Order: 243030

***Dear Customer,** thank you for your order. Please refer below technical queries observed during pre-production work on your supplied files. Request you to go through all below exceptions and confirm back your point wise replies in this same file to maintain the proper record.*

Problem description 1:

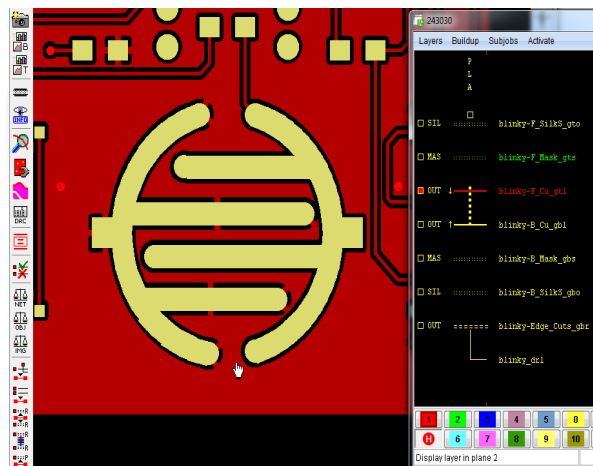
As per gerber data we have found one carbon type pad in top side but in order detail its option is not selected as shown in below screen dump picture.

We have continued order as it is as per gerber data without carbon contact.
